MEMORANDUM

SUBJECT: Nixon/Pleasant Change Order 1 – Wastewater Conflict Resolution

CITY OF ROLLINGWOOD, TEXAS
 CITY OF ROLLINGWOOD
 NIXON/PLEASANT DRAINAGE IMPROVEMENTS
 STORM SEWER PLAN & PROFILE
 STA. 10+00.00 TO STA. 12+67.58

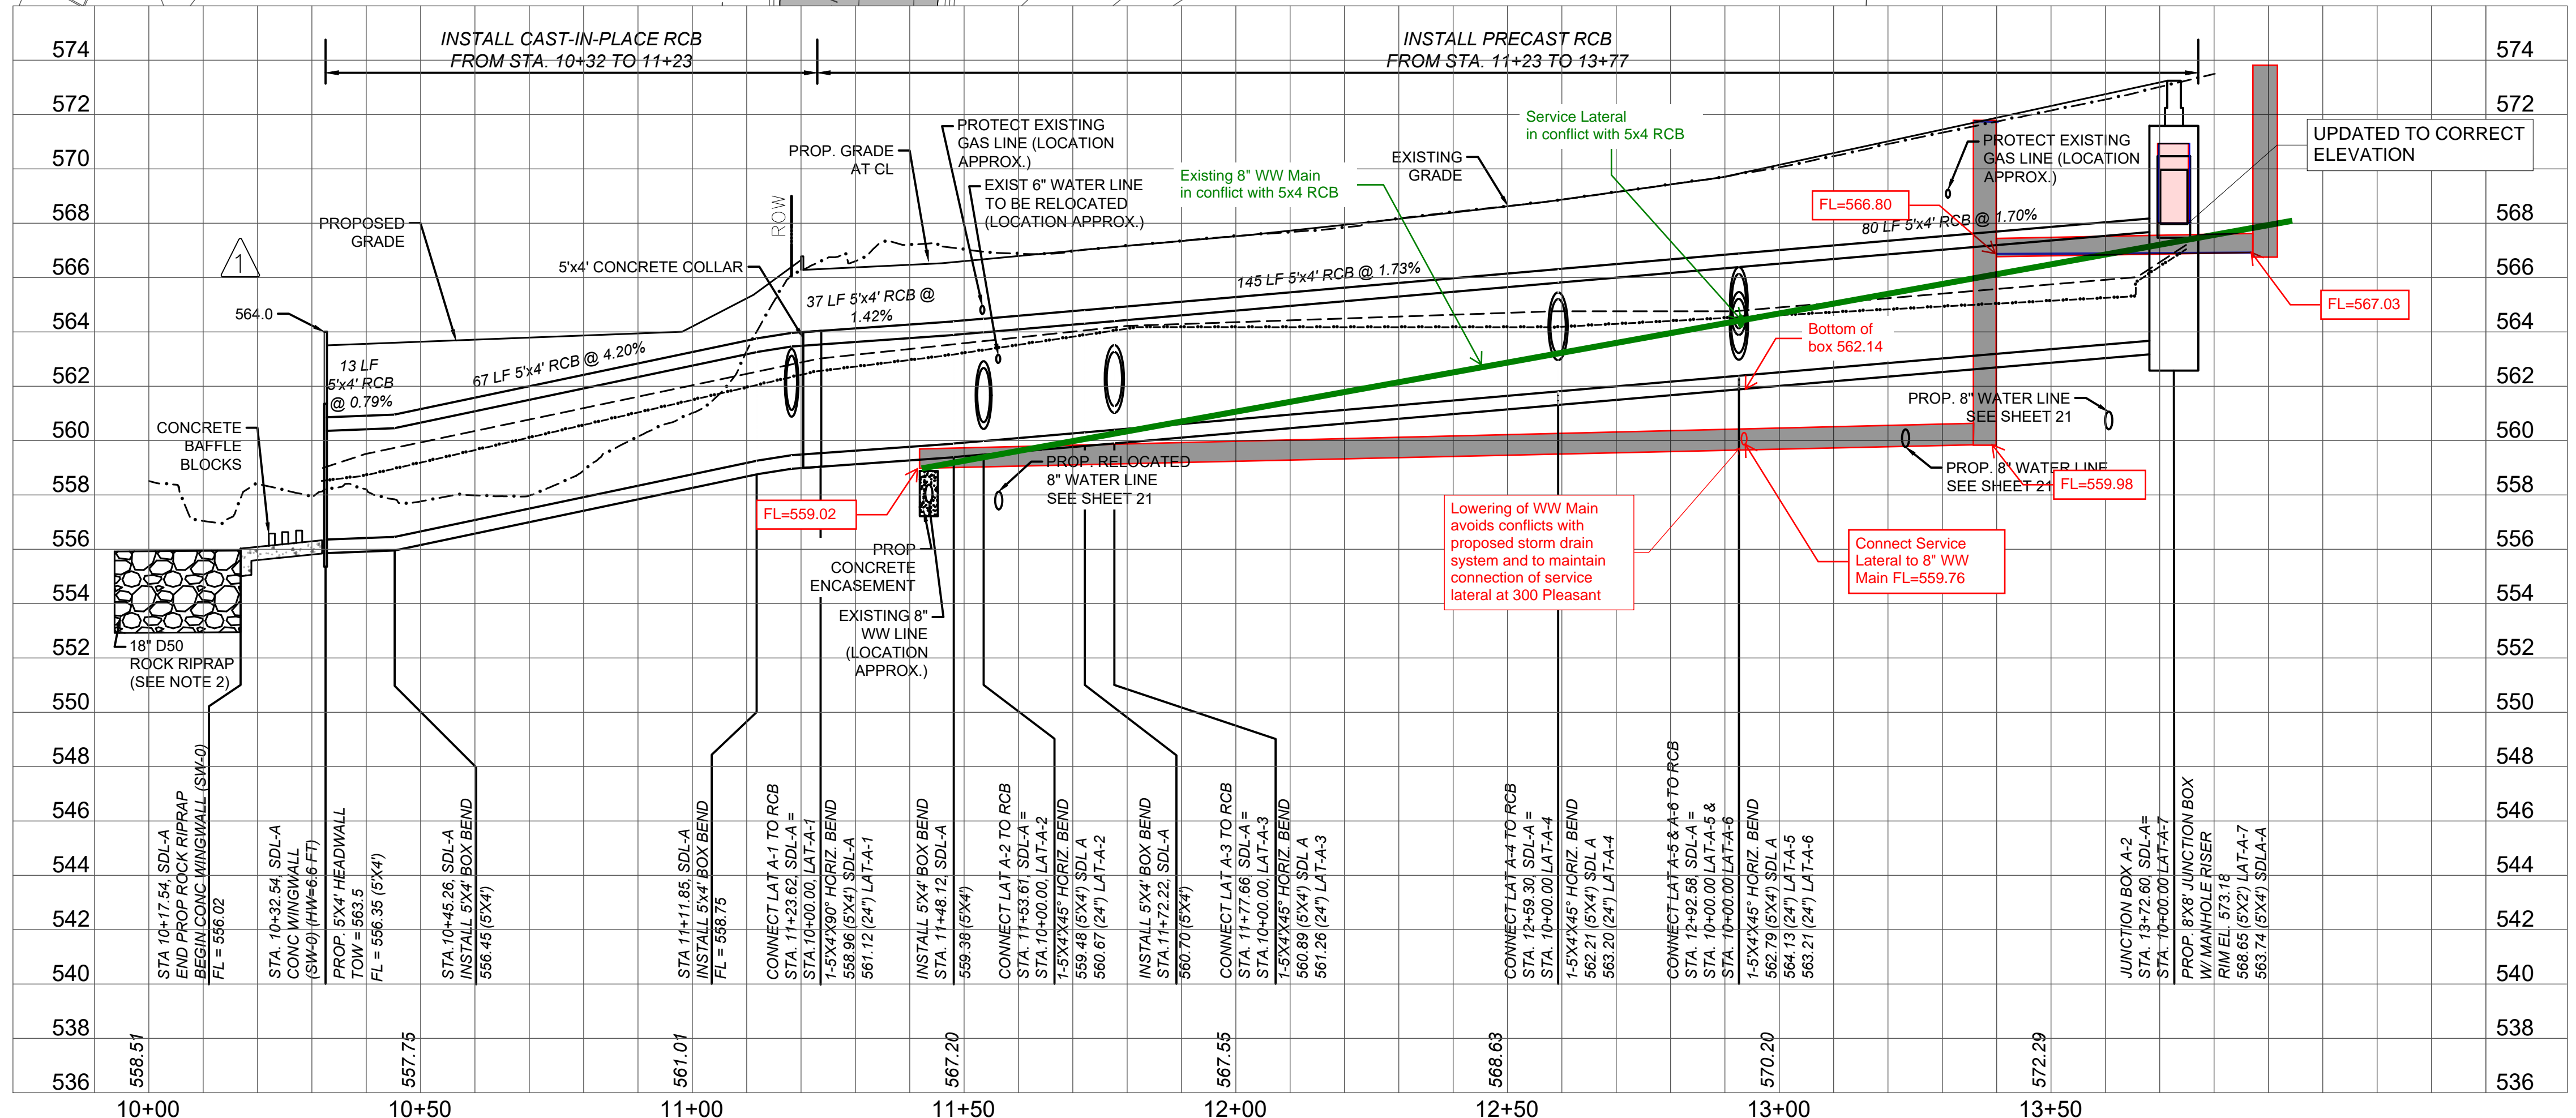
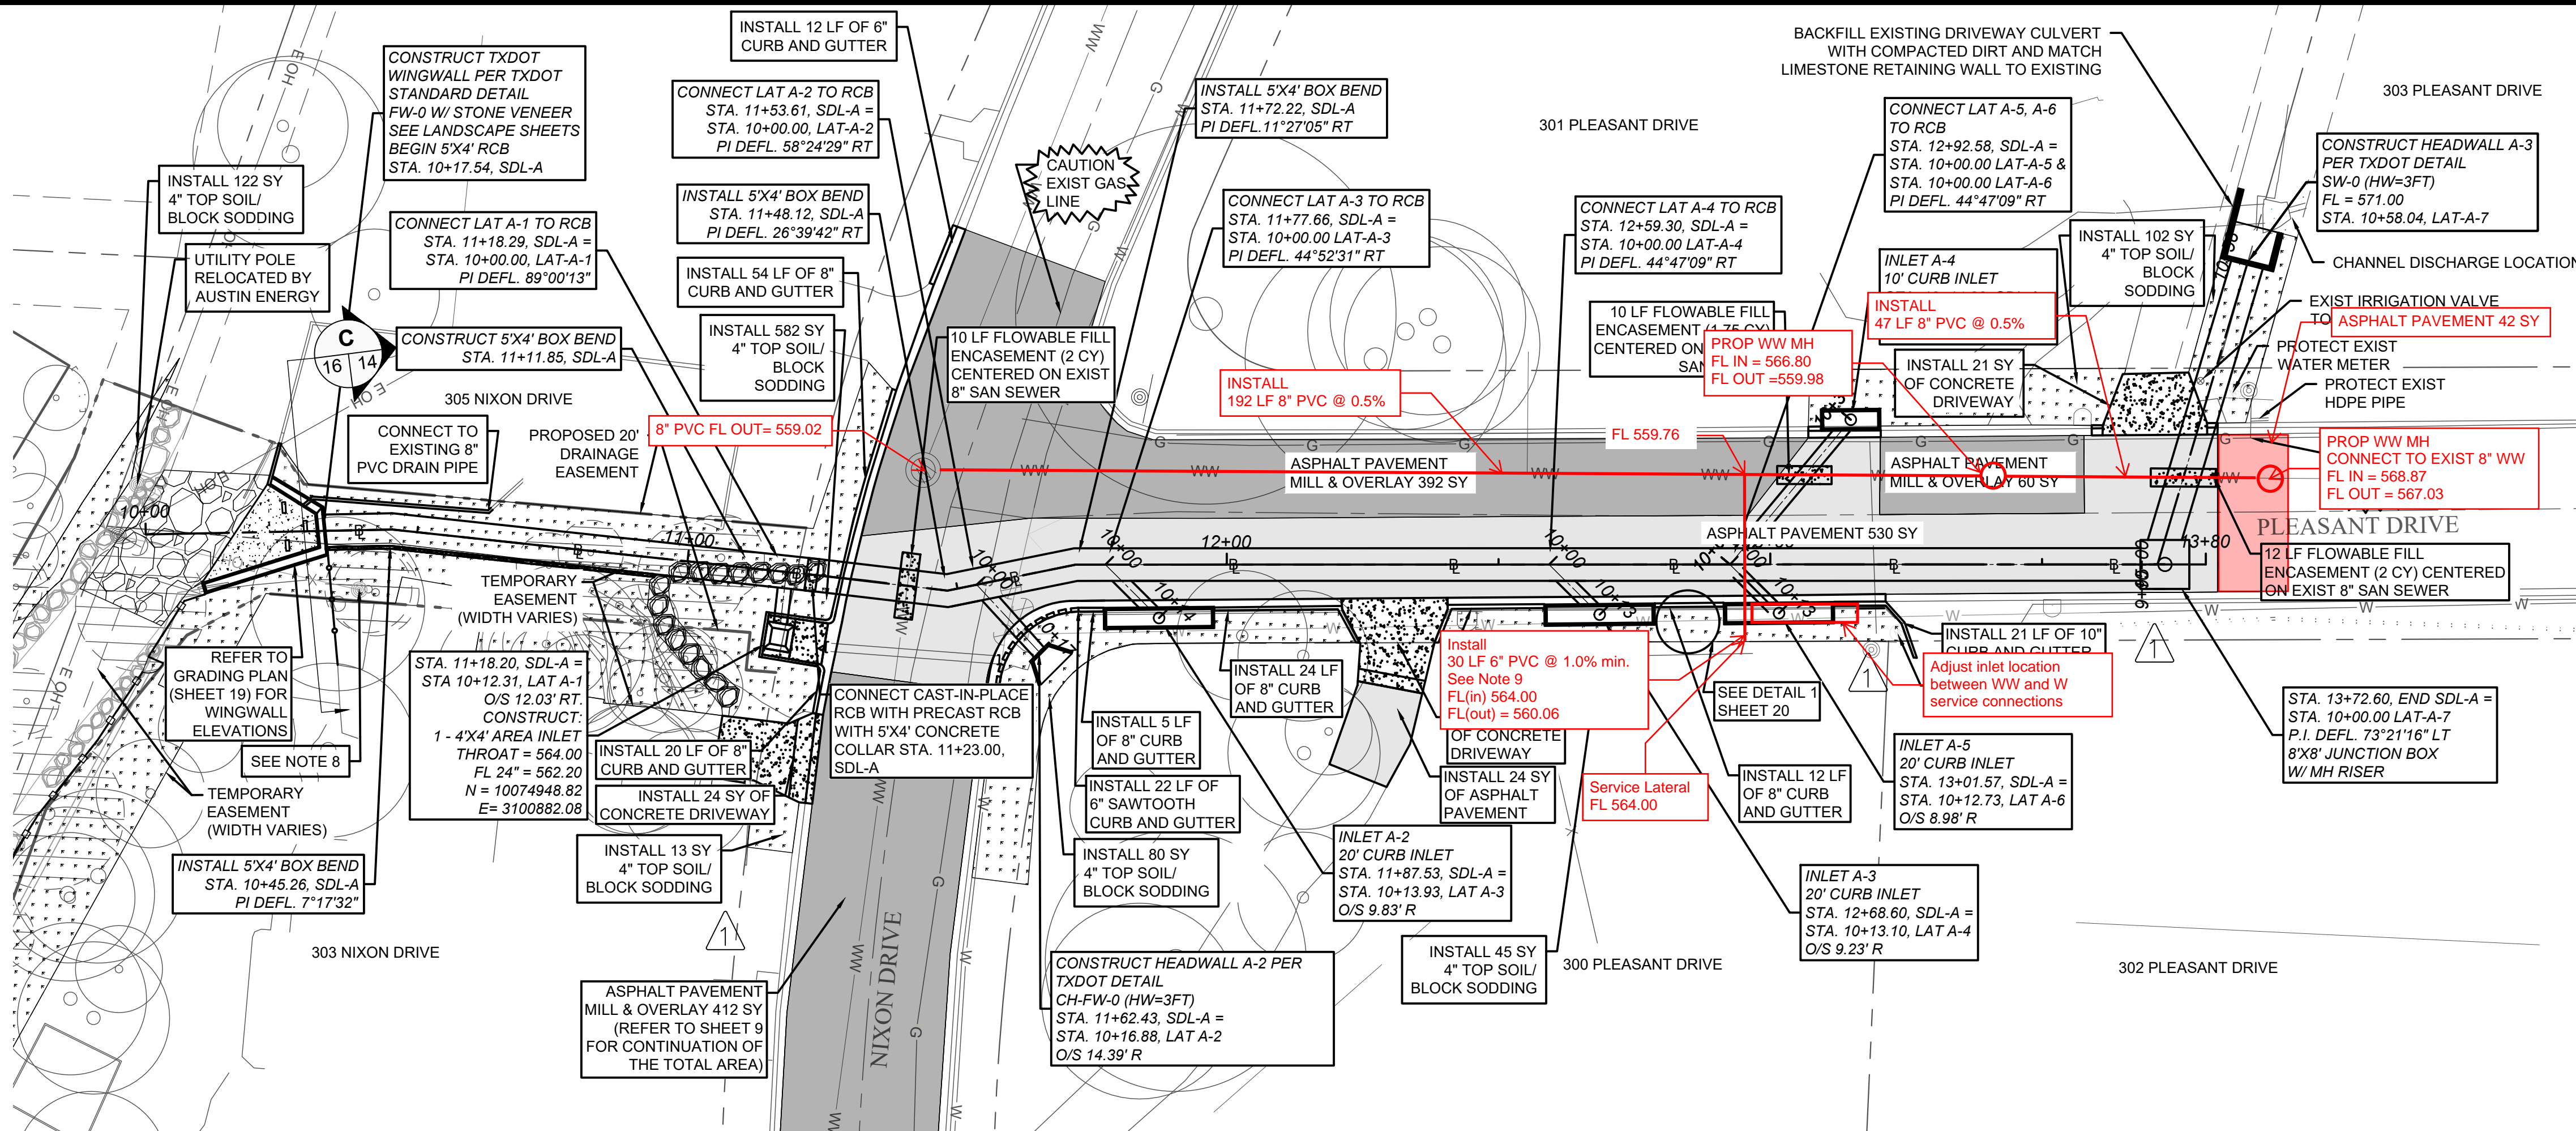
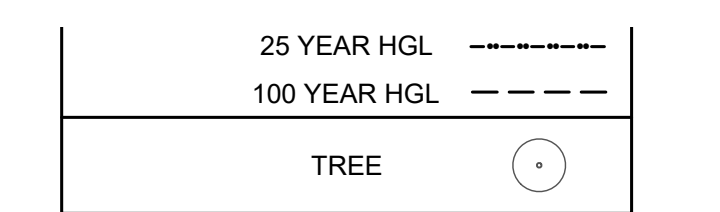
During the ongoing construction along Pleasant Drive, a conflict was identified between the proposed storm drainage infrastructure and the existing 8" wastewater main. Although this issue surfaced during construction, the necessary adjustment would have been required regardless of when it was identified—whether during the design phase or construction.

The storm drainage design relied on a combination of field survey data and record drawings. Survey data from the downstream manhole at Nixon and Pleasant Drive indicated a flowline elevation of 559.02', while record drawings for the upstream manhole showed an elevation of 574.95'. These elevations were used to calculate the slope of the wastewater main and confirm its clearance from the proposed 5x4 reinforced concrete box (RCB) storm drainage structure. However, during construction, it was determined that the actual elevation of the upstream manhole was 576.09' —approximately one foot higher than expected. This discrepancy placed the wastewater main in direct conflict with the storm drainage infrastructure and the lateral connection servicing 300 Pleasant Drive.

Even if this elevation difference had been identified during the design phase, the relocation of the wastewater main would still have been necessary. The proposed 5x4 RCB storm drainage structure is substantial, and its relatively shallow installation requires adequate vertical clearance, which the existing wastewater line, at its current elevation, cannot provide. Therefore, the relocation of the wastewater main is not the result of a design change, but a required adjustment to complete the project as planned and ensure the proper functioning of both the stormwater and wastewater systems.

upstream manhole FL 576.09 (421 LF)

9. Install 45 degree bends on lateral to achieve flowline elevation of 560.06. Slope of lateral to be maintained between 1% and 10%.
